75W MODIFICATION TO APPLICATION TO  
BARANGAROO CONCEPT PLAN (MP06\_0162 MOD 8)

## MOD 8 DRAFT CONDITIONS | PART B – MODIFICATIONS TO CONCEPT PLAN **RESPONSE TO CONDITION B3**

16 FEBRUARY 2016

**B Section B-B (Current)**

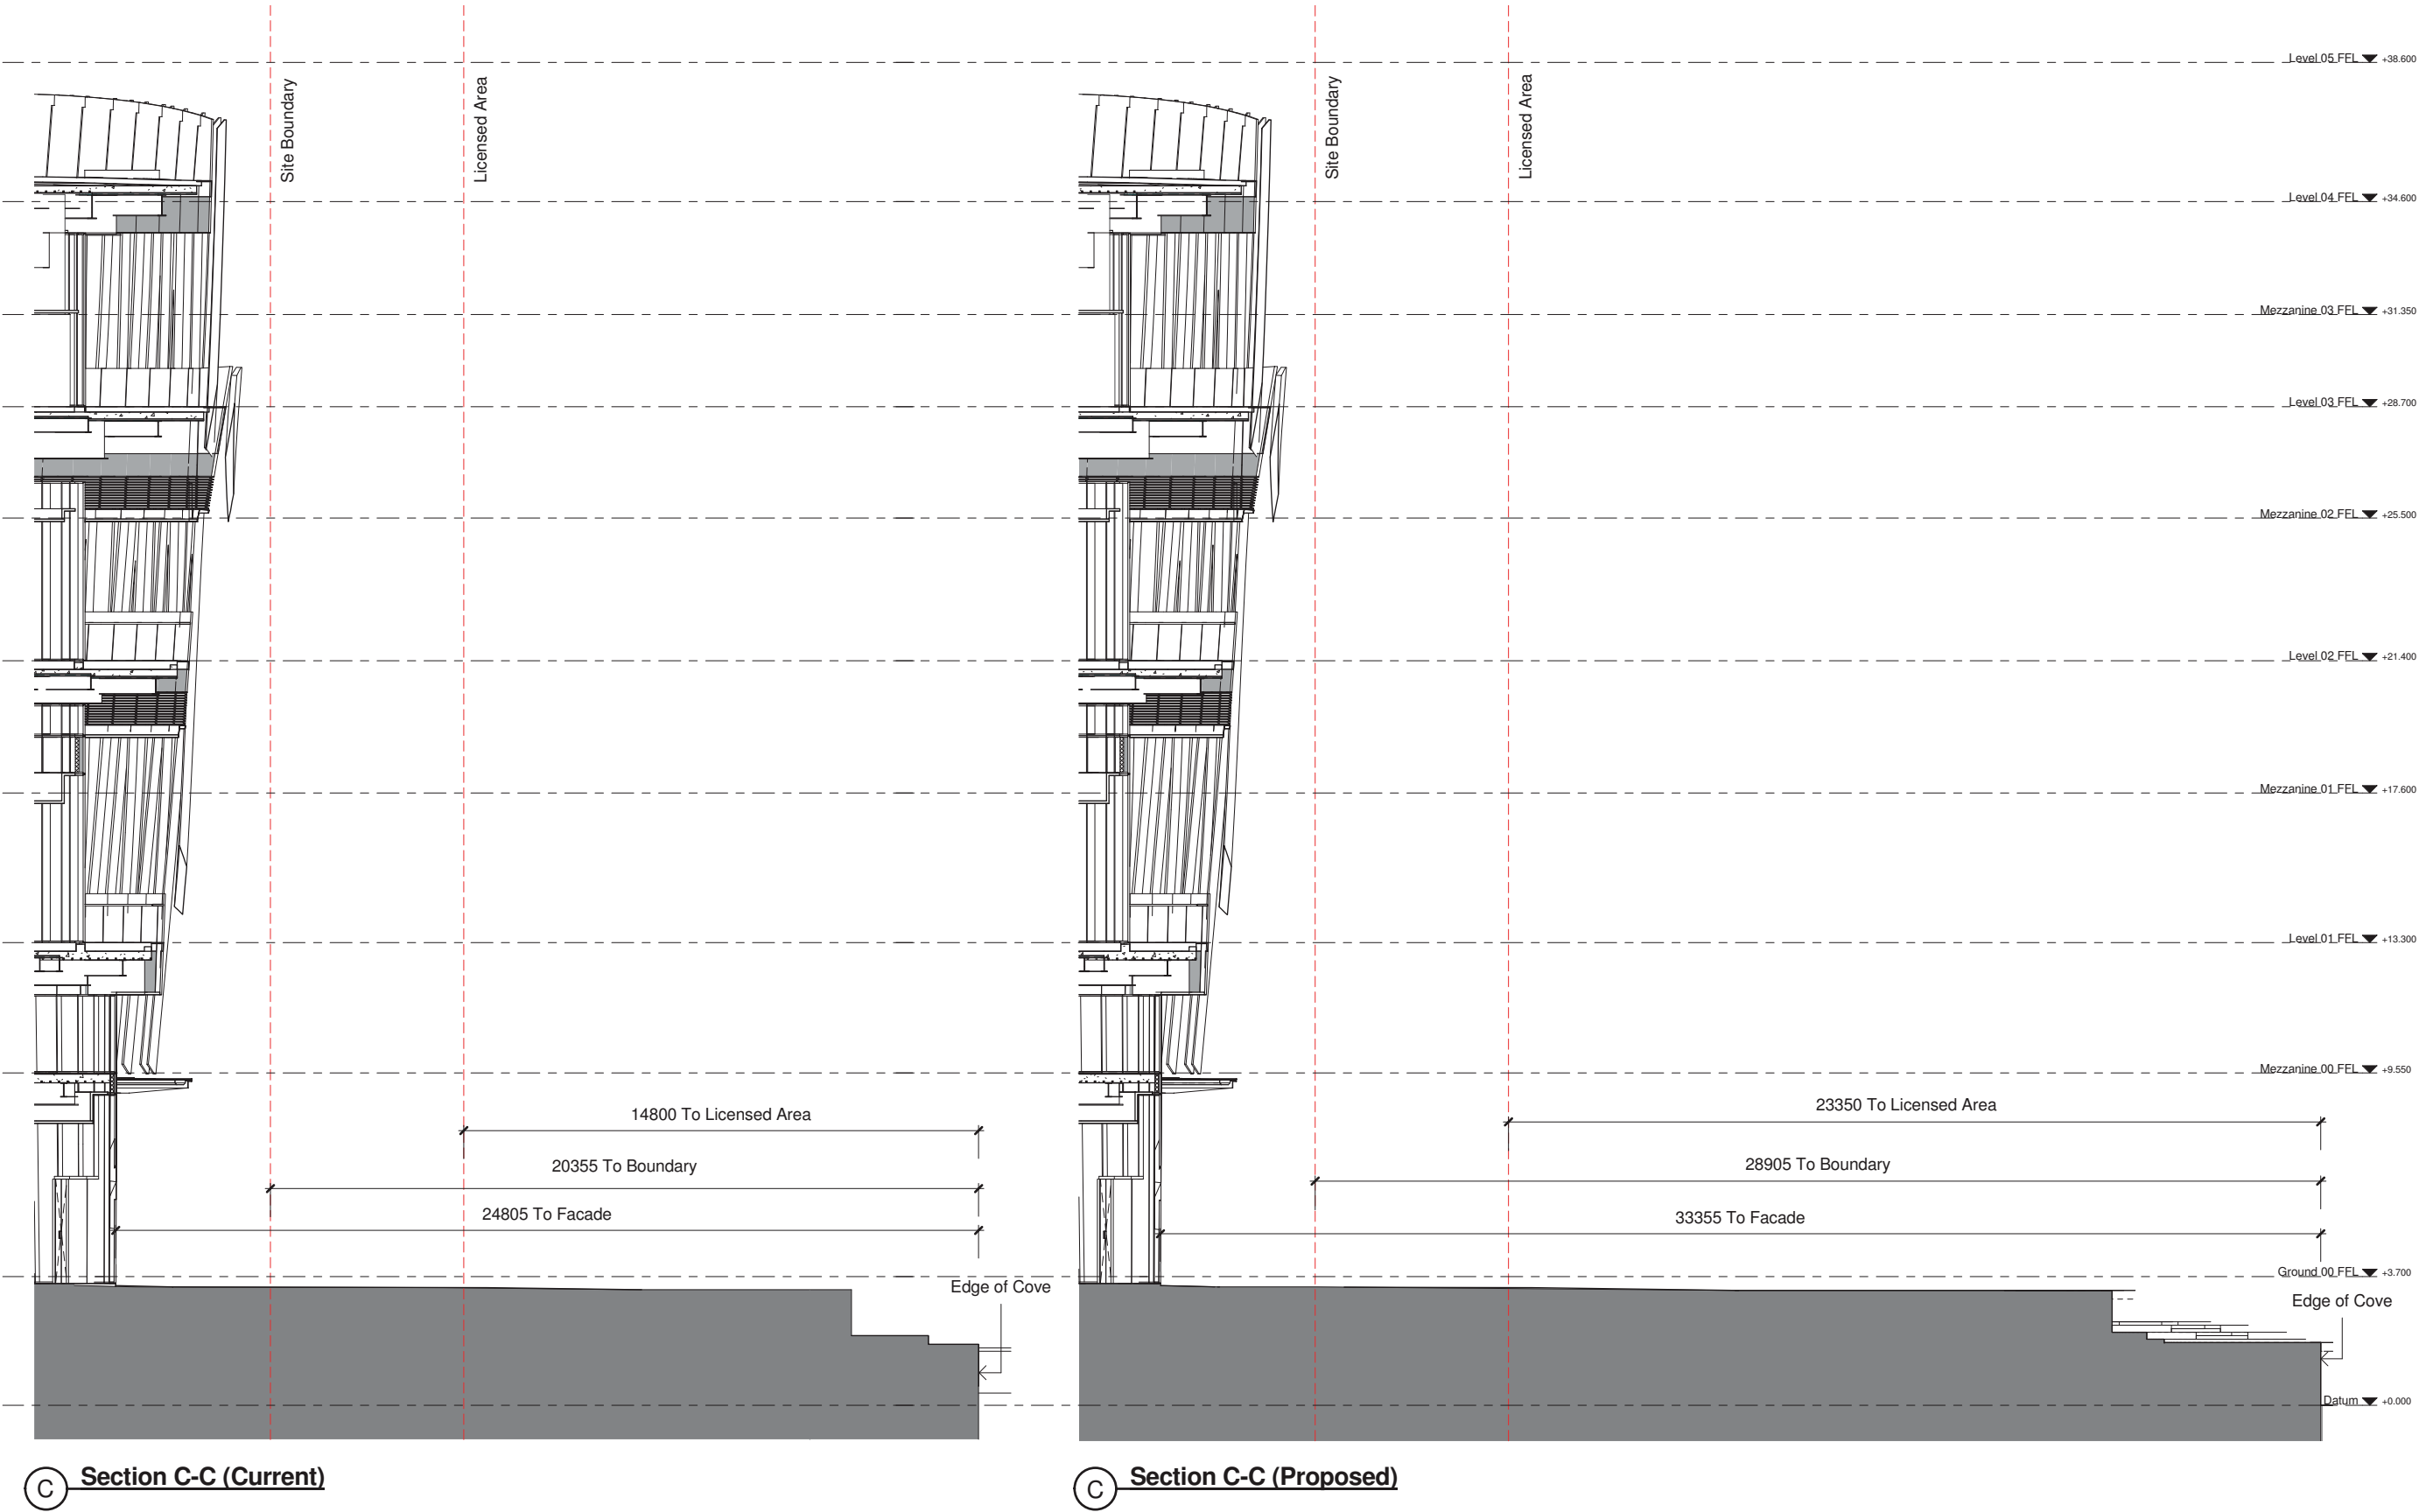
In addition to increasing the setback of the podium from the waters edge, Crown Resorts is proposing to modify the design of the southern podium elevation per the attached plans in an effort to minimize any perception that the podium dominates and overwhelms Watermans Cove.

*Aerial View*

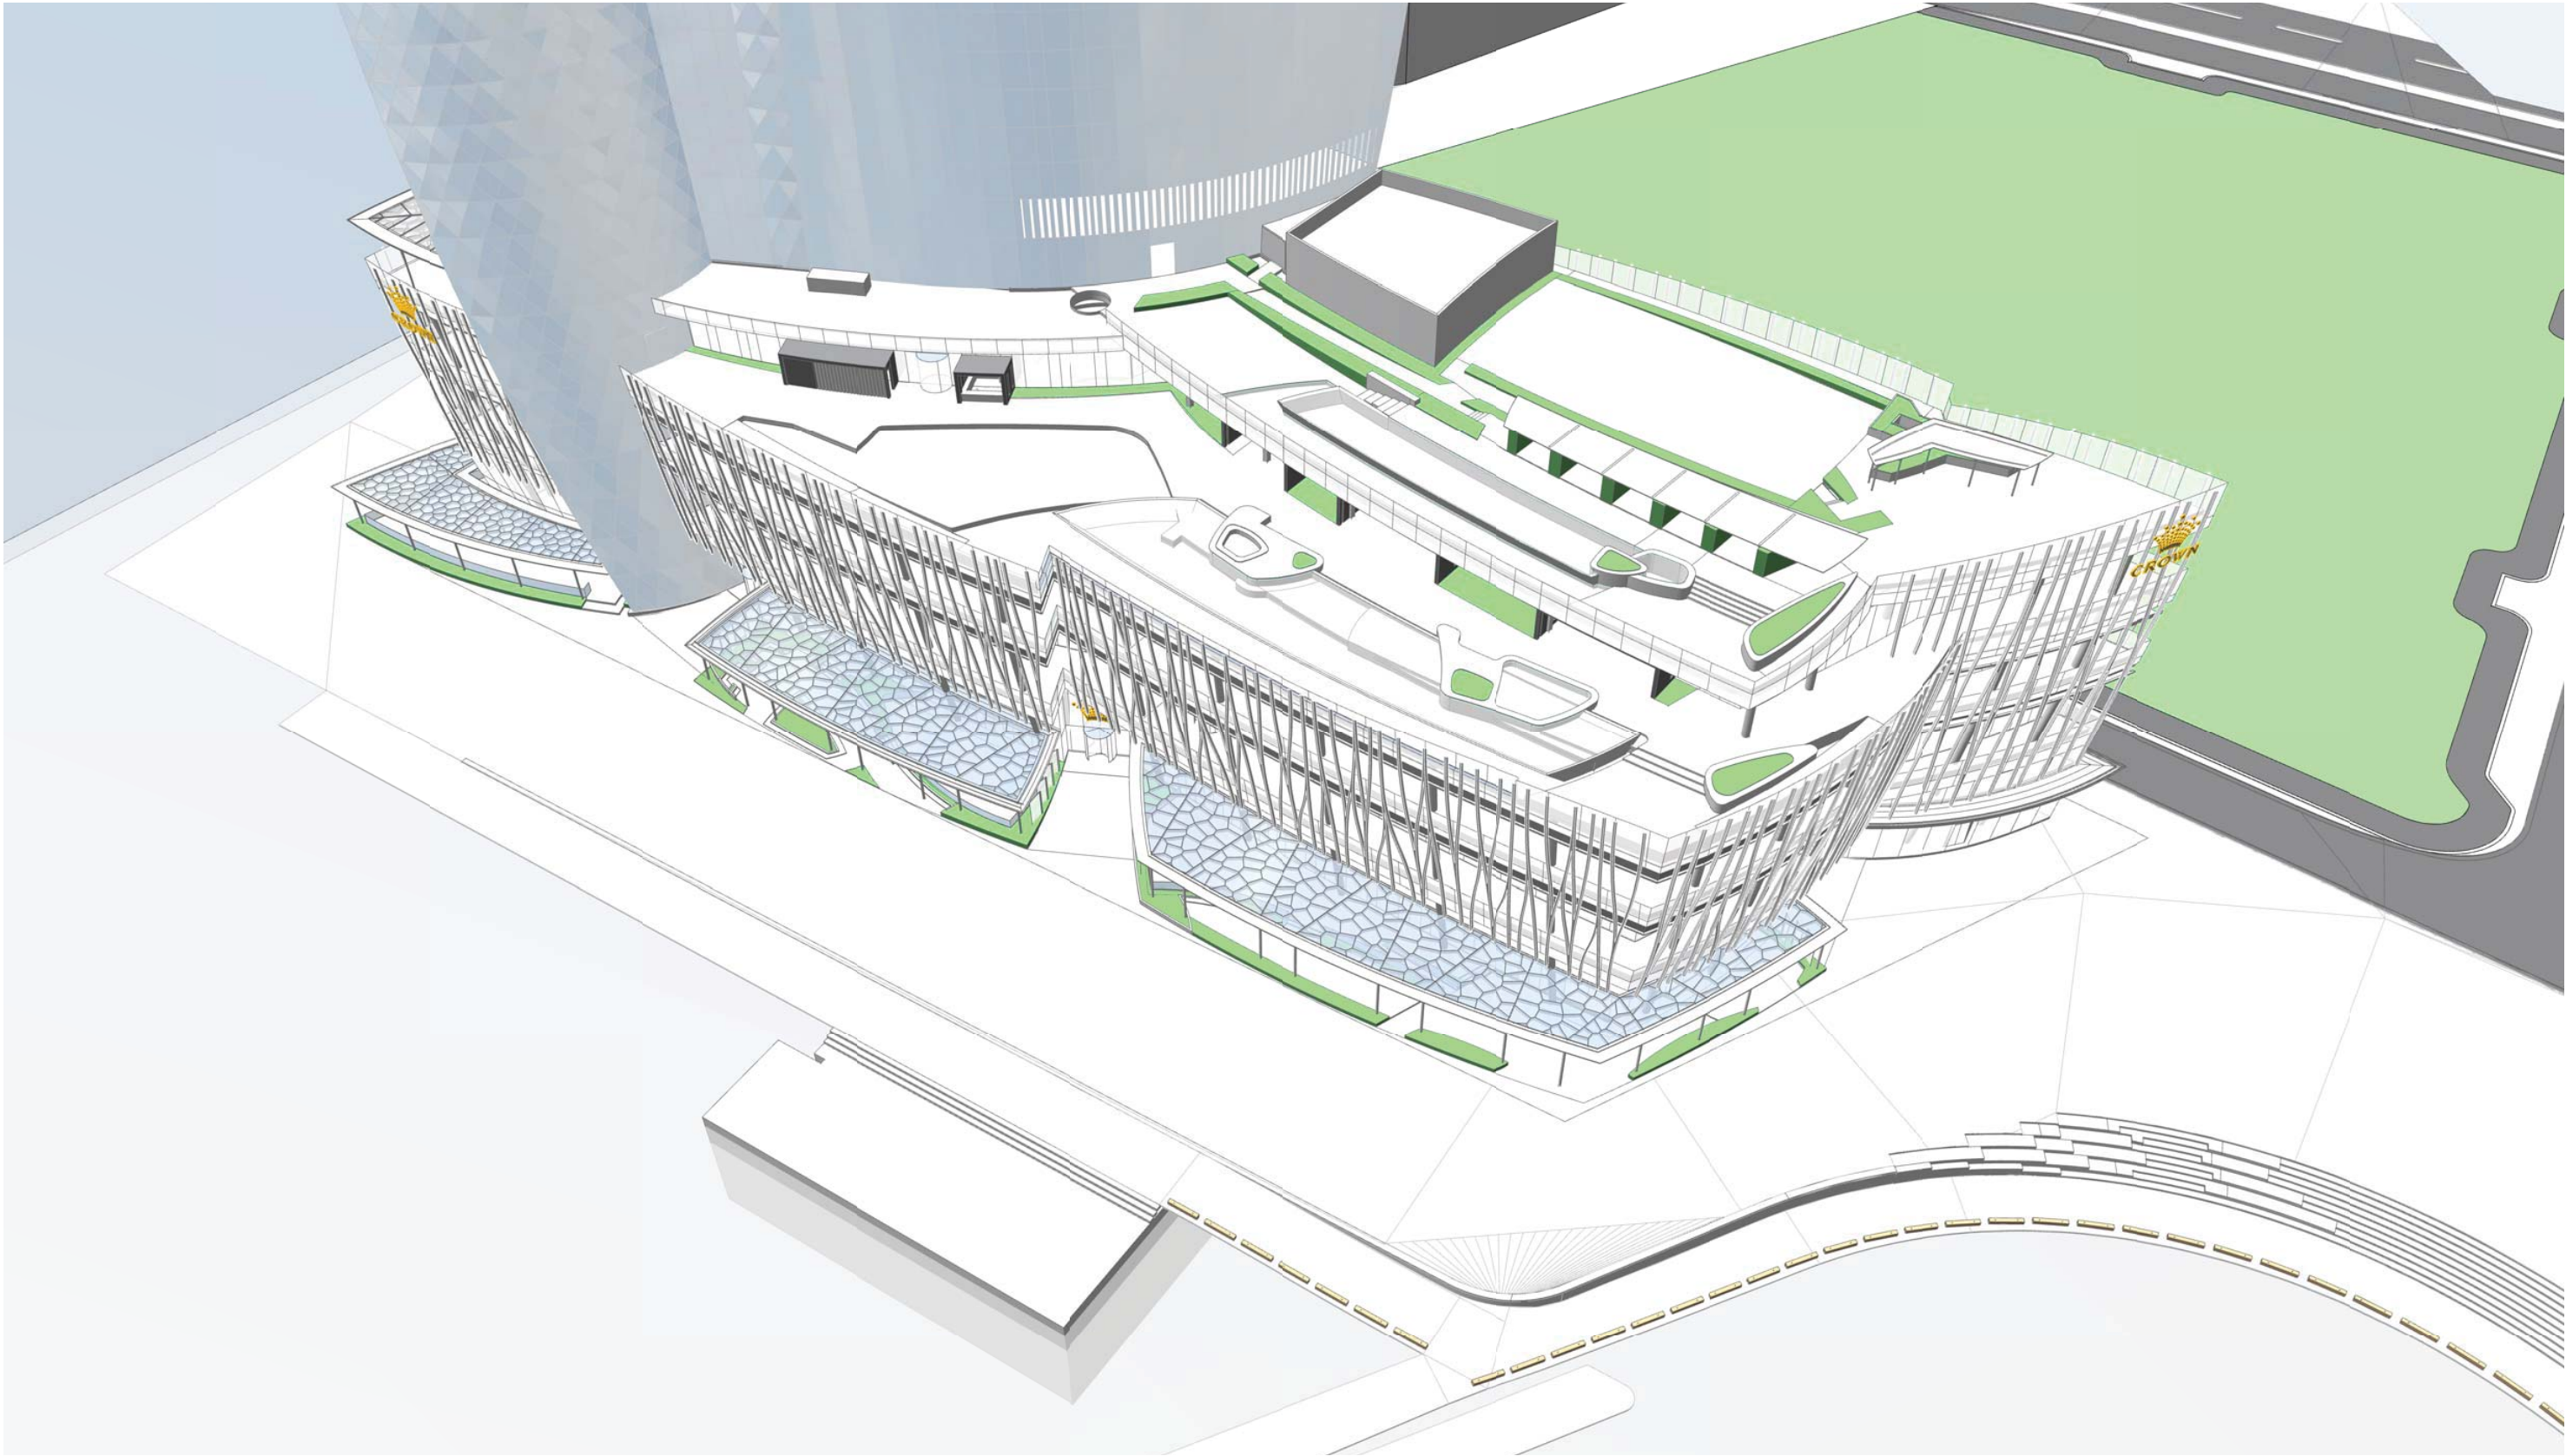
As illustrated within the attached plans, the westerly facade of the CSHR podium has been re-designed in order to break the podium structure up into distinct building elements that are now viewed as a segmented building in lieu of a continuous built form.

By re-designing the podium facades in this manner, the overall perceived length of the façade is significantly reduced when viewed from the surrounding Public Domain and from across the harbour.
